EX PARTE REEXAMINATION COMMUNICATION TRANSMITTAL FORM

PATENT NO. : 7293385

Office Action in Ex Parte Reexamination	Control No. 90/013,341 and 90/013,655 merged	Patent Under Reexamination 7293385	
	Examiner JEFFREY R. JASTRZAB	Art Unit 3993	AIA (First Inventor to File) Status No

Reexamination Control No.: 90/013,341)
U.S. Patent No.: 7,293,385)
Issue Date of Patent: November 13, 2007) Group Art Unit: 3993
Filing Date of Application: January 9, 2007) Examiner: JASTRZAB, JEFFREY R.
Inventor: MICHAEL L. MCCORMICK) Attorney's Docket: 11065P-REX-004
Title: MODULAR TRIGGER GROUP FOR)
FIREARMS AND FIREARM)
HAVING A MODULAR TRIGGER)
GROUP)

(Fig. 2, with added notation by the Examiner taken from the Reexam Request; Fig 1 without annotation)

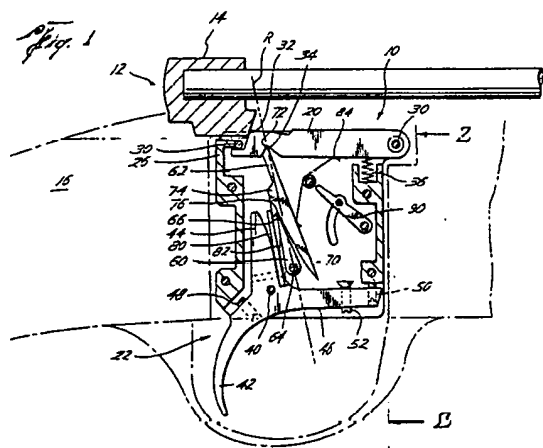
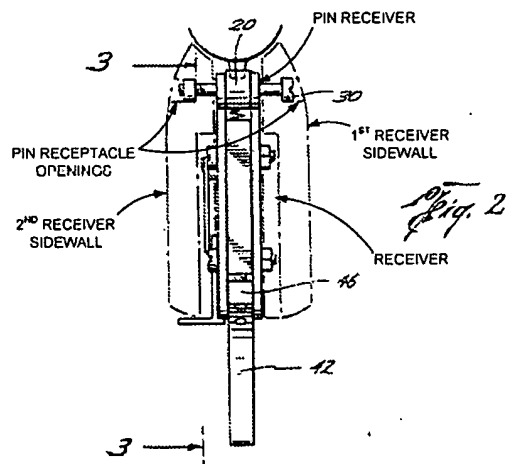
Jewell discloses a firearm (rifle 12). The firearm has a receiver formed in the stock (16) (see Fig. 1). The receiver defines a trigger group receiving area between a first receiver side wall and a second receiver side wall (see Fig. 2). Although Jewell apparently discloses a bolt receiver (not shown, see col. 3, lines 65-68), the term "receiver" is interpreted in this reexamination proceeding as being the portion of the firearm that houses the firearm's operating parts, including the bolt and the trigger

group. Accordingly, the *receiver* in Jewell is the combination of the bolt's receiver and also the cavity that receives the housing 26. See annotated Figure 1, below.

Each of the first and second receiver side walls includes a first pin receptacle opening, which functions to define a pin support surface. Figure 2 shows the receptacle openings of the firearm supporting a pin (30).

Jewell further discloses a module housing (housing 26) located in an operating position in the trigger group receiving area of the firearm (as shown in Figs. 1, 2; see col. 3, lines 64-65).

(Fig. 4, with added notation taken by the Examiner from the Reexam Request)

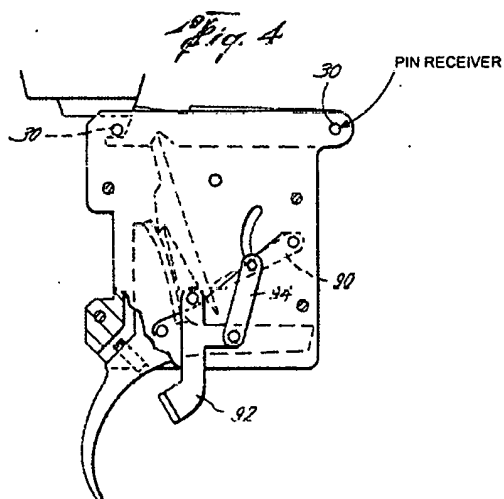
Jewell additionally discloses a number of trigger group components mounted within the module housing, including an arm lock means (20), a trigger piece (22), and a link mechanism (24) components (see col. 4 lines 1-3; Fig. 1).

Jewell further discloses a first pin receiver positioned in the module housing and aligning with the first pin receptacle openings of the firearm (see Figs. 2, 4). Jewell includes a first pin receiver in the module housing (26), substantially defined by an opening/aperture in each of the housing walls through which a pin (30) passes (see Fig. 3). As shown (see Fig. 2), the pin receiver is positioned so as to align with the first pin receptacle openings of the firearm while the module housing (26) is in the operating

Jewell further discloses a first module pin mounted in the first pin receiver. As evident in Figure 1, Jewell has a trigger group component (i.e., an arm lock means/arm lock 20) supported in the module housing about the pin (30) which is received in a pin receiver. Also present is a pin-receiving sleeve that receives the pin (30) therein (again see Fig. 1). This is also described by Jewell's specification (see col. 4, lines 4-5): "The arm lock means 20 is pivotally mounted to a housing 26 on a sleeve about pin 30" This passage would tend to indicate that the sleeve also defines a component-supporting pin.

(Fig. 2, with added notation by the Examiner taken from the Reexam Request)

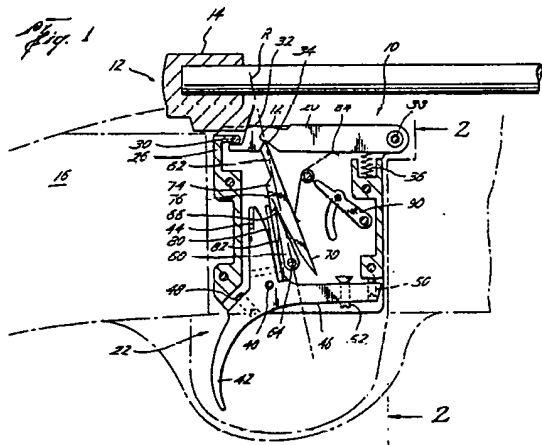
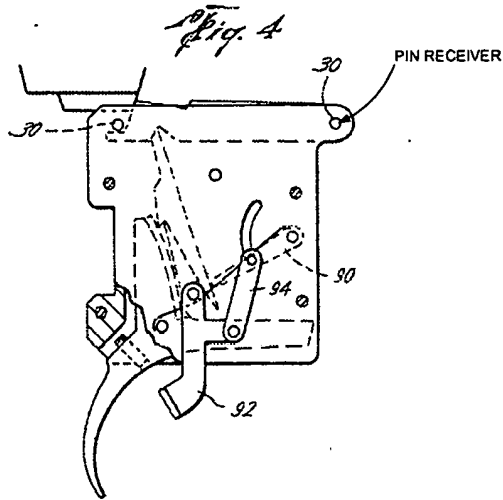
Jewell also discloses a first pin receiver positioned in the module housing so as to align with first pin receptacle openings of a firearm when the module housing is in an operating position. Jewell's first pin receiver in the module housing (26) is substantially defined by an opening or an aperture in each of the housings walls, through which a pin (30) passes. As demonstrated, this pin receiver would be capable of being positioned for aligning with opposed pin receptacle openings of a firearm when the module housing (26) is in a position within a firearm's receiver (see annotated versions of Figs. 2, 4 below), by which to permit the pin receptacle openings of the firearm to function as pin support surfaces in the firearm's receiver side walls.

Jewell further discloses a first module pin mounted in the first pin receiver in the module, on which a trigger group component is supported in the module housing. As evident in Figure 1 (see above), Jewell has one of its trigger group components (i.e., an

arm lock means/arm lock 20) supported in the module housing (26) about a module pin (30). The pin is received in a pin receiver (the openings in the module side walls; see annotated Fig. 2).

Also present is a pin-receiving sleeve that receives the pin (30) therein (again see Figs. 1 and 2). This is also described by Jewell's specification (see col. 4, lines 4-5): "The arm lock means 20 is pivotally mounted to a housing 26 on a sleeve about pin 30" This passage would tend to indicate that the sleeve also defines a component-supporting pin. Jewell further discloses the following regarding the sleeve being connected (in some manner) to the housing (see col. 6, line 67 - col. 7, line 7):

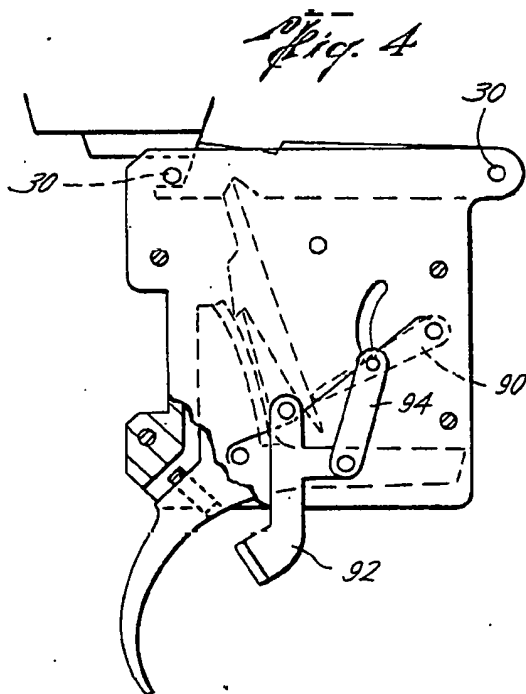
Claim 2 is to a trigger group module *for* a firearm. Accordingly, the trigger group module is structurally set forth in claim 2, whereas the firearm in this claims is read not as *structure* but as *intended use*. Therefore, the recitations in claim 2 of the locations of the module or module's components relative to the firearm merely define *functional limitations* related to that *intended use*.

Regarding the additional limitations set forth in claim 2, Jewell of the art combination discloses a second pin receiver in the form of a second opening for a second pin (30). See Figure 4.
